Docket Item # 8 & 9
BAR CASE #2018-00061 & #2018-00062

BAR Meeting
March 7, 2018

ISSUE: Partial Demolition/Capsulation and Alterations

LOCATION: 1321 Duke Street

Figure 6: Front façade signage above the third-floor windows

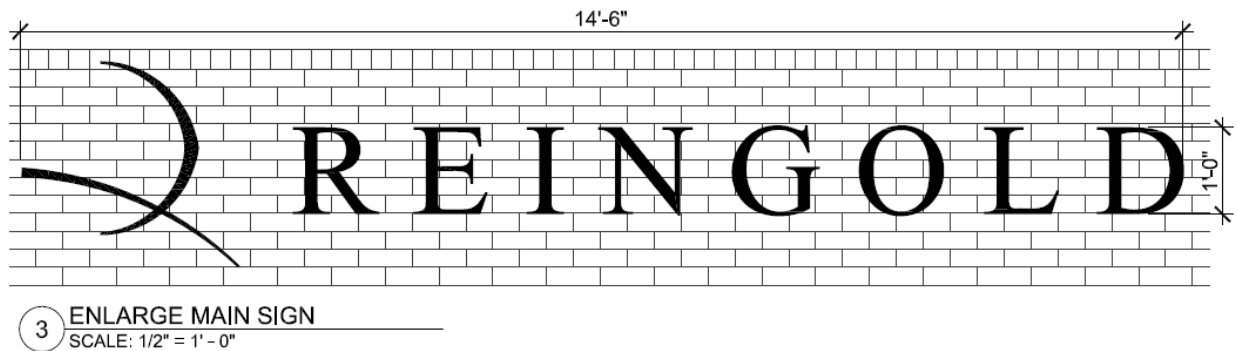
Staff recommends that the wall sign with pin-mounted letters on the façade above the third-floor windows be installed on a wood frieze board or sign band but not directly installed into a masonry wall to reduce the anchors into the building. The anchors for all signs must be installed into the mortar joints on masonry buildings to avoid damage to the brick or stone. Alternatively, the applicant could use a silicon adhesive instead of the sign band or wood frieze board, this would also reduce the number of anchors into the masonry, although silicon is difficult to remove and can have masonry staining issues when it comes time to remove a sign. The logo sign on the east elevation requires further zoning review prior to application for sign permits.

1. The wall sign on the façade above the third-floor windows must be installed either on a wood frieze board or sign band painted to match the adjacent masonry or use of a silicon adhesive to reduce the future damage to the masonry wall of the building as signs change.
2. The anchors for all signs must be installed into the mortar joints on masonry buildings to avoid damage to the brick or stone.
